Re: Trans Mountain Pipeline ULC ("**Trans Mountain**")  
Trans Mountain Expansion Project ("**TMEP**" or "**Project**")  
File OF-Fac-Oil-T260-2013-03 60  
**Section 211 Deviation Application for PPBoR Sheet M002-PM03025-001**

2. The revised detailed route ("**Revised Route**") is shown on the revised PPBoR Sheet attached as Appendix A, and the location of the Revised Route in relation to the approved detailed route ("**Approved Route**") is illustrated in the maps attached as Appendix B. The Revised Route is entirely within the corridor approved by Certificate of Public Convenience and Necessity ("**CPCN**") OC-065.

**COQUITLAM SEGMENT 7.4 SHEET: 1 KP 1166+742 TO KP 1168+082**

**TRANS MOUNTAIN EXPANSION PROJECT  
PLAN AND PROFILE OF TMEP EASEMENT  
KP 1166+742 TO KP 1168+082  
092G02K**

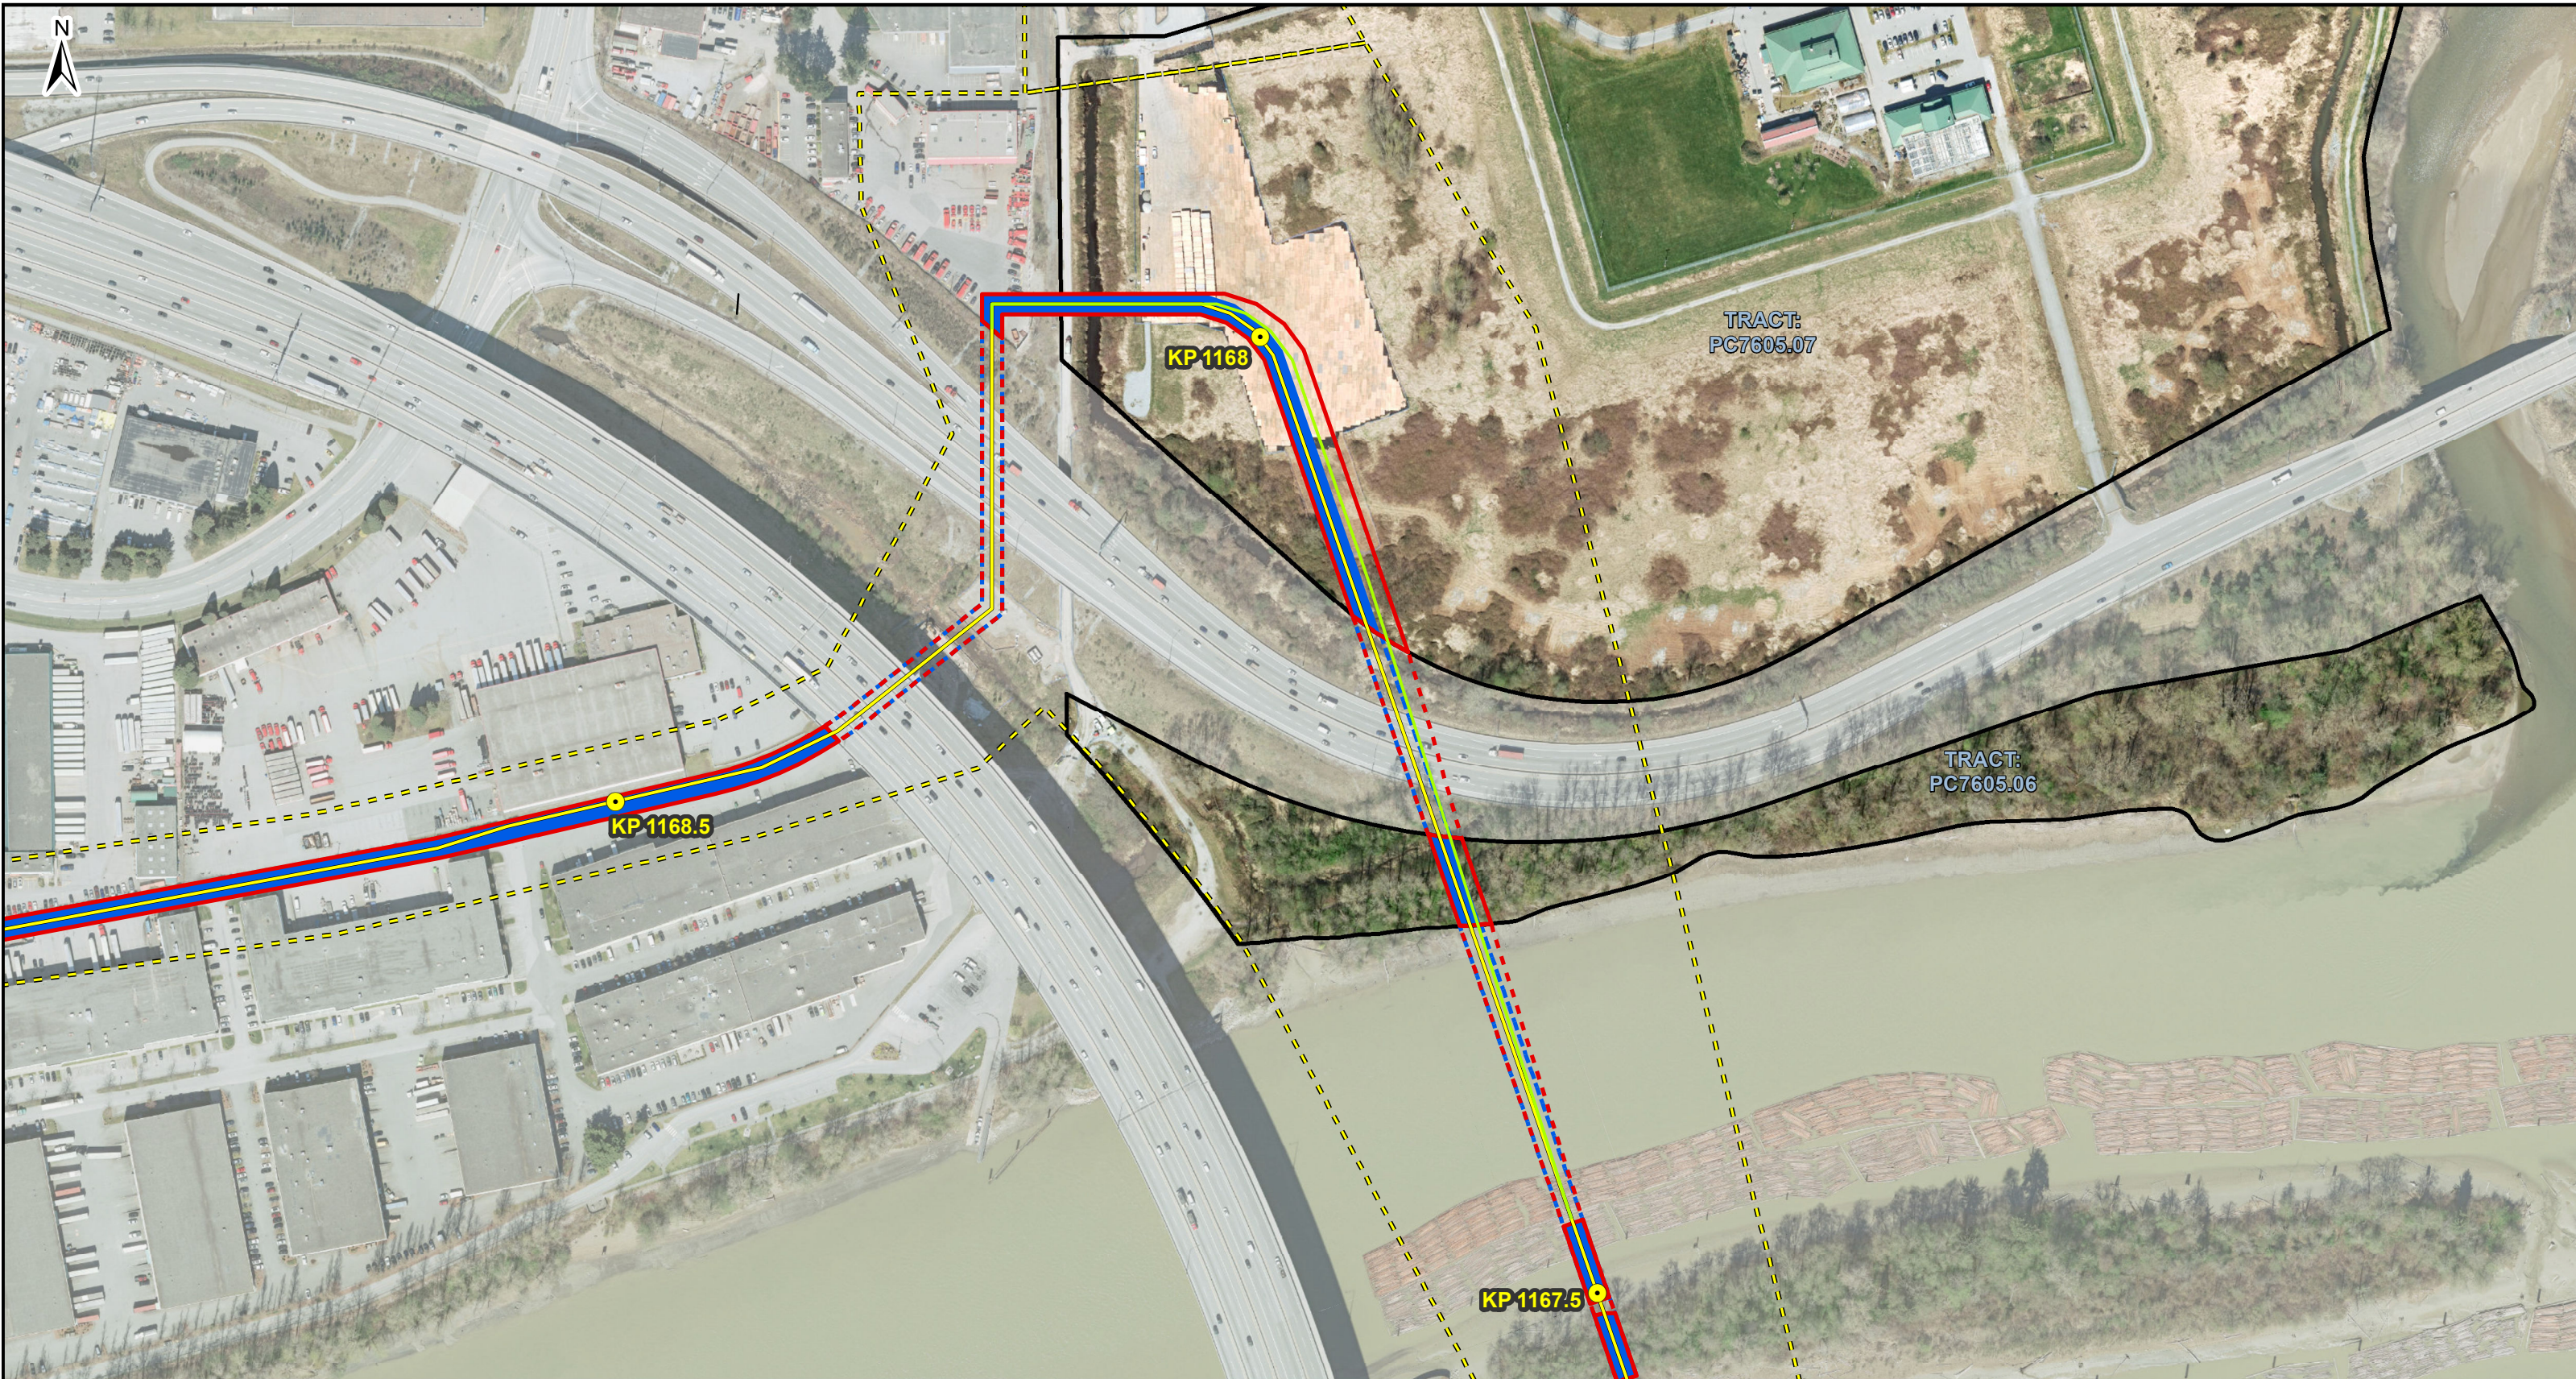
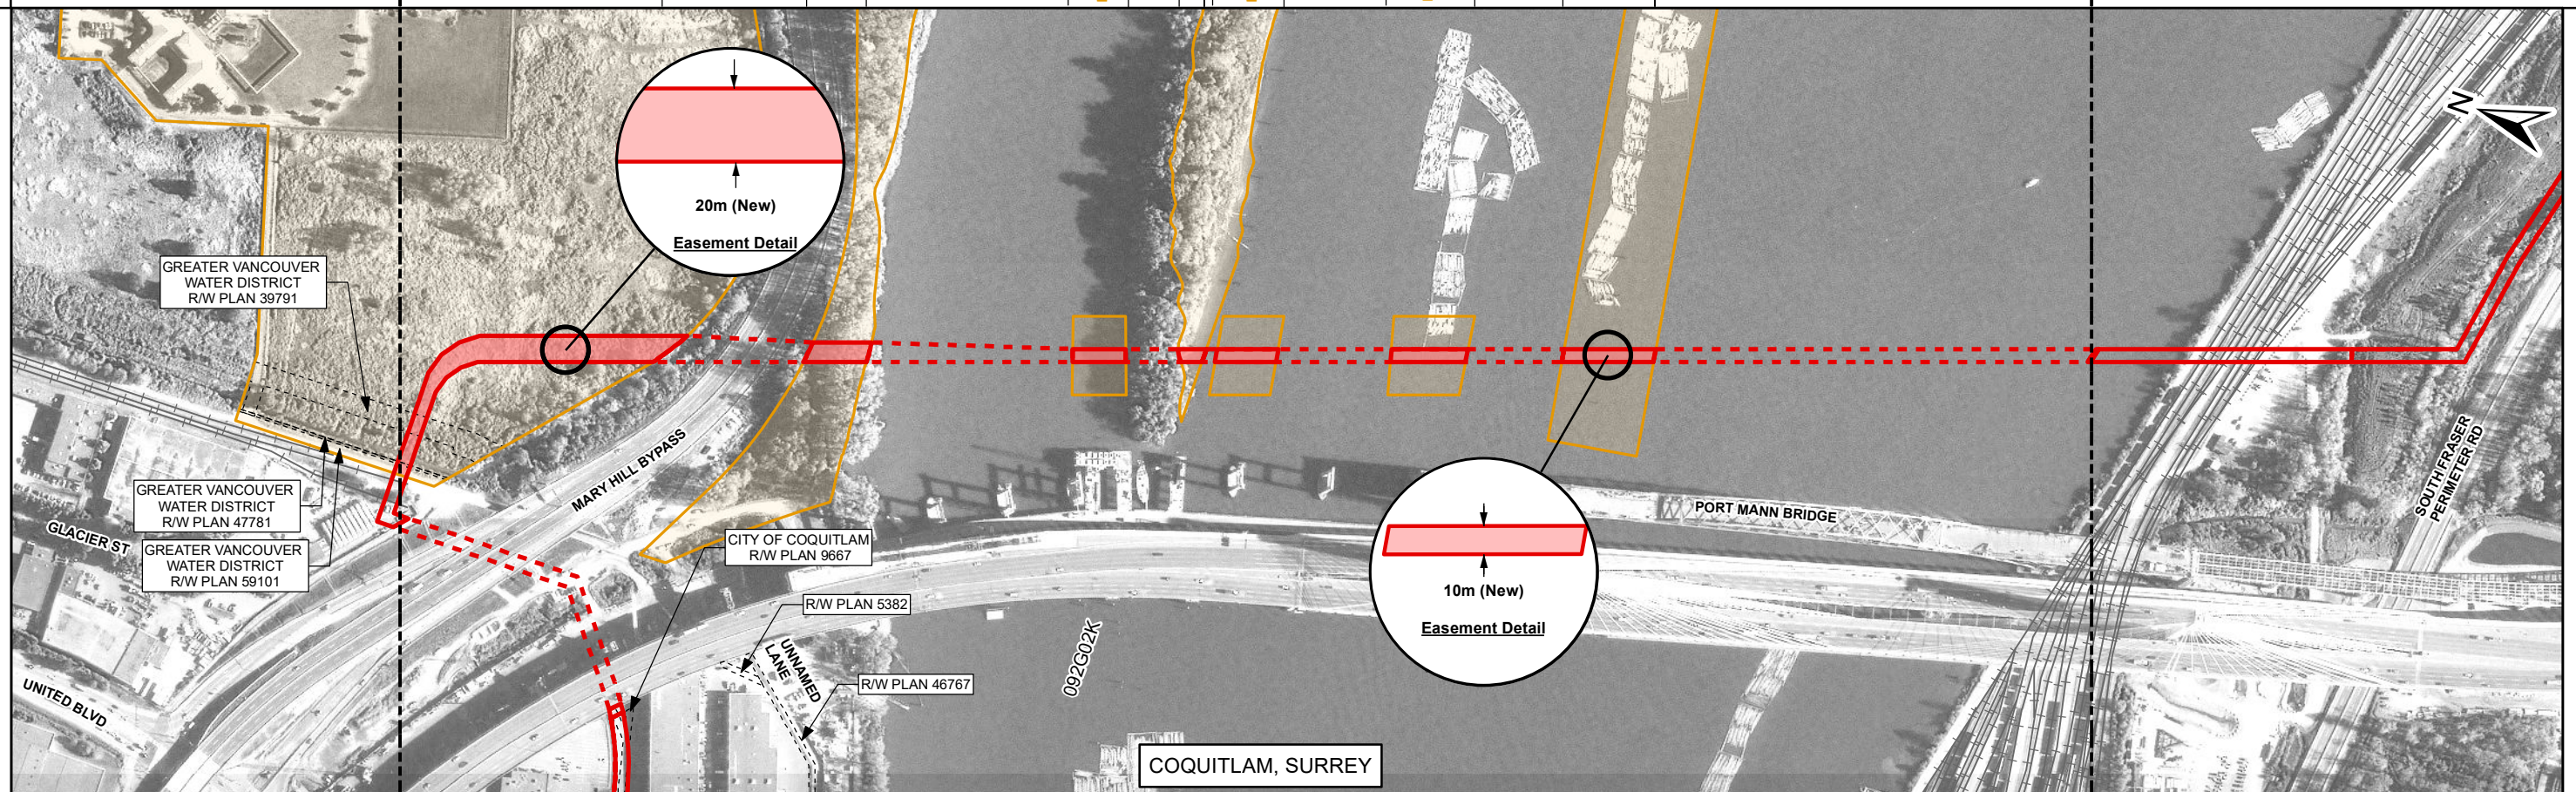
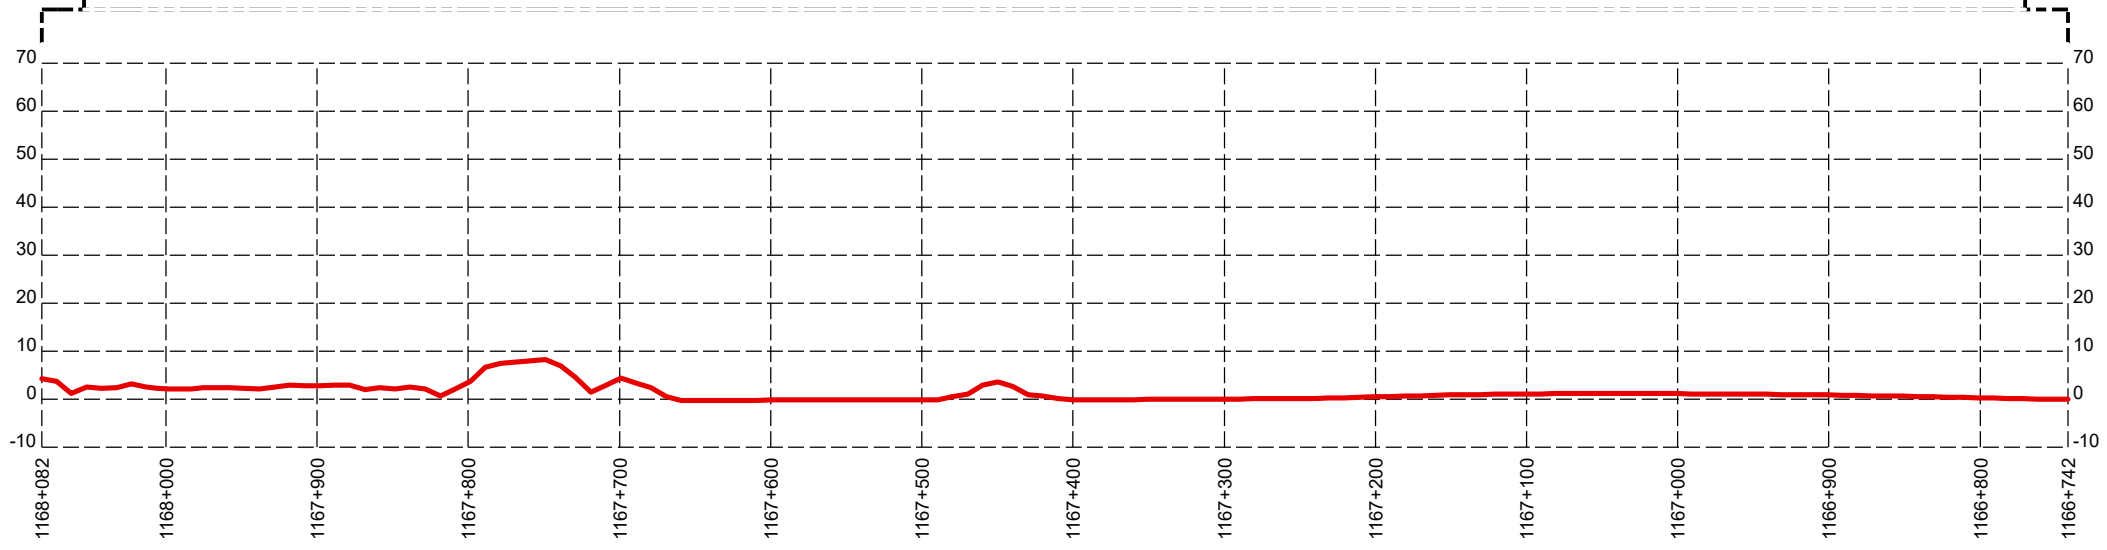
10. To complete the Fraser River HDD, Trans Mountain is proposing to re-use the majority (approximately 80 to 90%) of the HDD path, with the exception of the exit section in Coquitlam. Trans Mountain is proposing to relocate the exit point for the HDD closer to the Mary Hill ByPass and laterally to the east by a total of 8 m. This proposed relocation seeks to avoid the area where the drill pipe failed and allow the first portion of the new bore path to be drilled in relatively undisturbed ground for an approximate length of 332 m before it intersects with the successfully completed portion of the drill path. As shown in the attached Appendix B, the Revised Route requires an expansion of the TMEP right of way areas on the Lands by approximately 10 m in width, for a total of 20 m in width.

<b>TRANS MOUNTAIN PIPELINE</b>				
TRANS MOUNTAIN EXPANSION PROJECT				
DETAILED MA TRACT NUMBER: PC7605.06, PC7605.07				
<i>NOT FOR CONSTRUCTION</i>				
SCALE	ROUTE	DRAWING NUMBER	SHEET NO.	REV
1:3,000	005.28.5	M002-PM06334	1 of 1	A

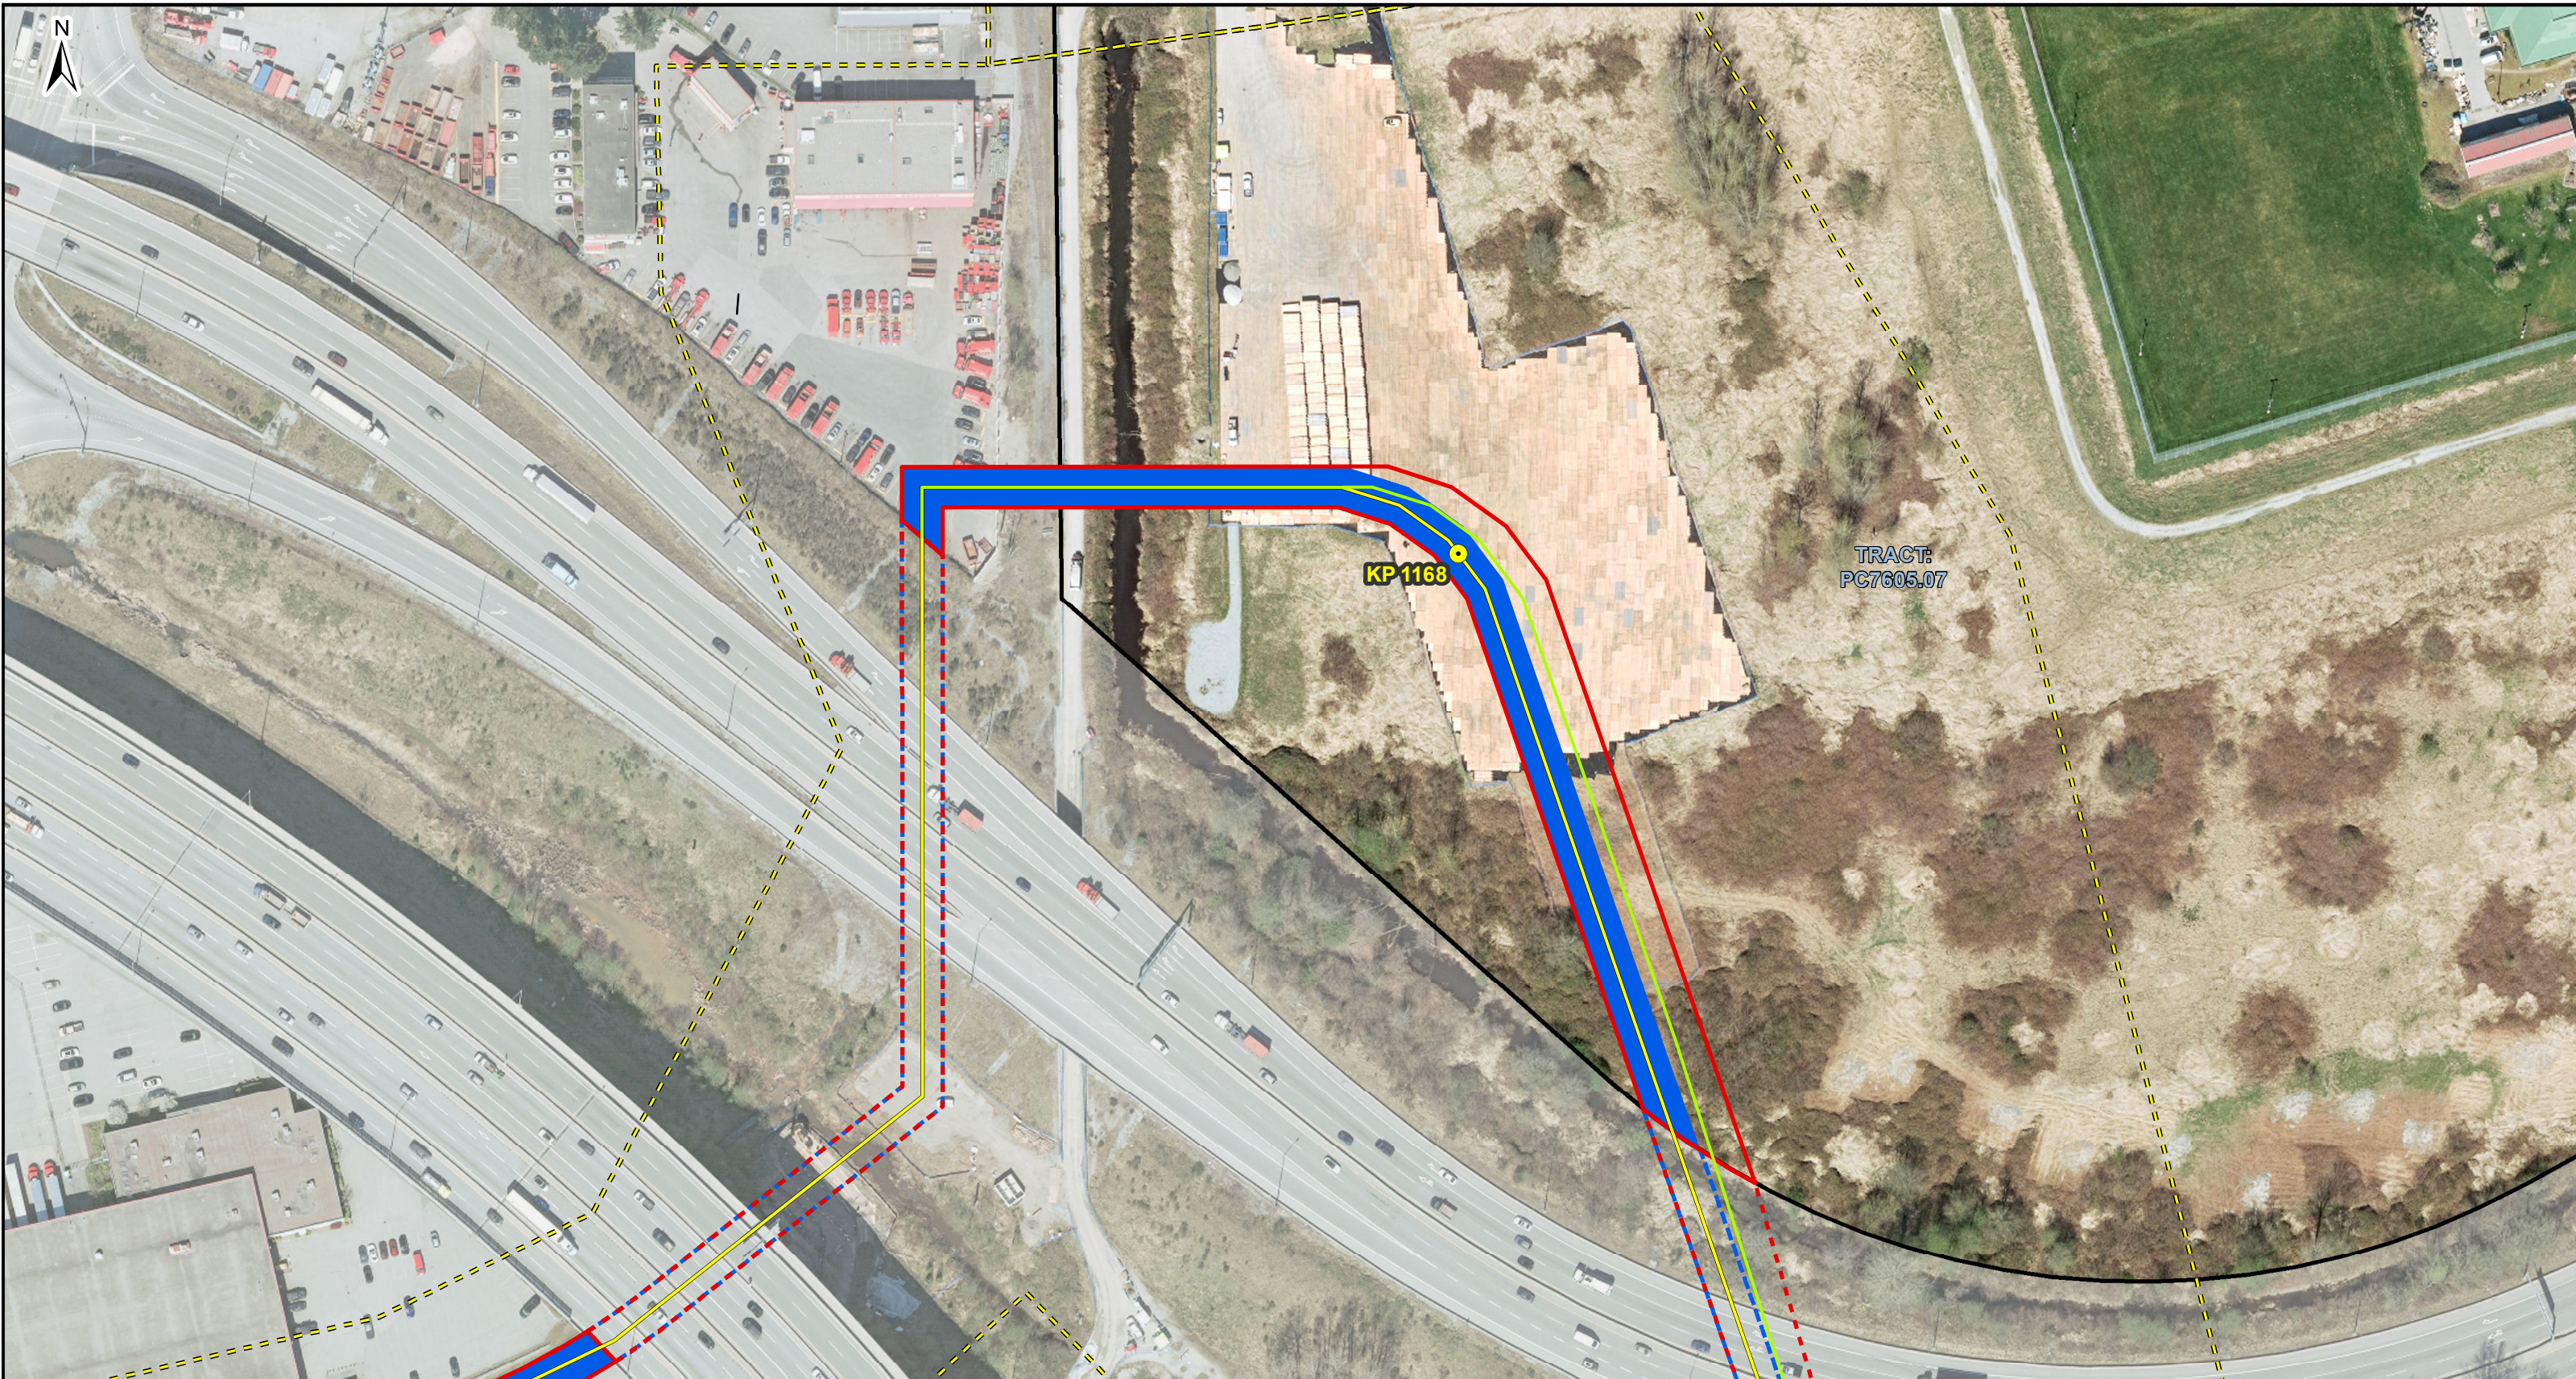
11. The proposed crossing design for the Revised Route, as described above, allows a section of 100-130 m of casing to be installed to protect the Mary Hill ByPass from settlement and potential fluid releases. The Revised Route further minimizes risks of potential failure by allowing the carrier pipe to be installed in a single section (instead of two as required for the Approved Route), thereby eliminating the need for stopping drilling operations to weld on the second section.
